Urban Design Consultation Response

Consultee Department:	
Officer Name (consultee):	██████████ Urban Design and Heritage Manager
Application Reference:	24/00987/FUL
Address:	Former Whitewebbs Park Golf Course, Whitewebbs Road, Enfield EN2
Description of development:	Change of use of former golf course (Use Class F2) to provide a football training centre (Sui Generis) and parkland (Use Class F2), comprising of football pitches and associated infrastructure; change of use, modification and extension of the existing Northern Clubhouse building to provide football training centre and associated uses (Sui Generis); restoration and enhancement of parkland landscape, including new footpaths; reinstatement of historic carriageway in Whitewebbs Wood; modifications of existing Southern Clubhouse to form a replacement cafe and public toilets, alongside a part change of use to include a flexible community space (Use Class F1/F2/Class E); demolition of existing grounds maintenance building and construction of replacement grounds maintenance building; construction of gatehouse; hard and soft landscaping works to include land reprofiling; new vehicular and pedestrian access, including formation

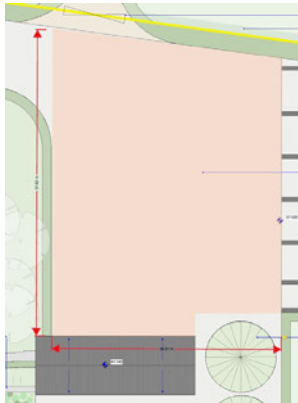
- 2.1.3 It is welcome that one of the attenuation ponds has been included in the public access of the site. However it would be preferable for both to be located in the public realm. Further justification is required to explain its exclusion.

2 NORTHERN CLUBHOUSE - PROPOSED GA ELEVATION BB
 18/21/ SCALE 1:100

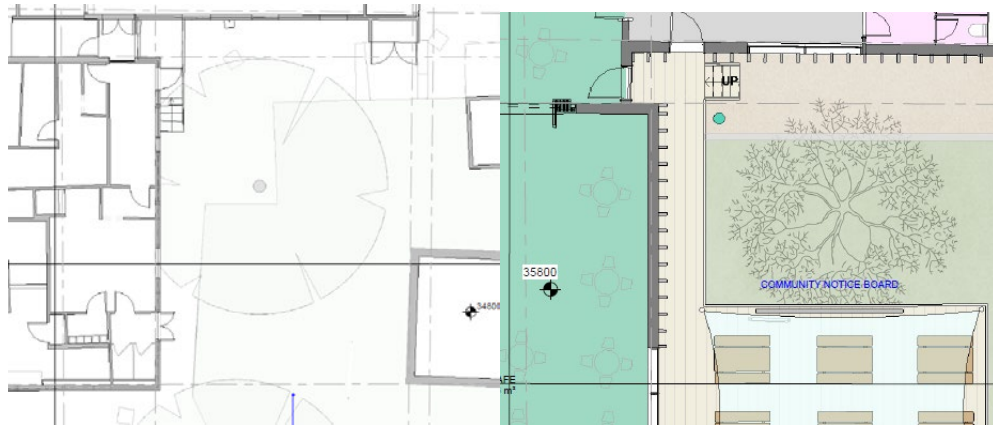
3.5.2 There is insufficient separation between the extension and the historic stableblock. The materiality and treatment at ground floor works well to create a contemporary and complementary gap between the old and new building. However the pitched roof connecting both elements (highlighted below) does not follow this approach and undermines the desired affect by clumsily joining the two with an incongruous connecting element. A continuation of the contemporary approach, perhaps using glass, timber in an orthogonal shape, would resolve the issue.
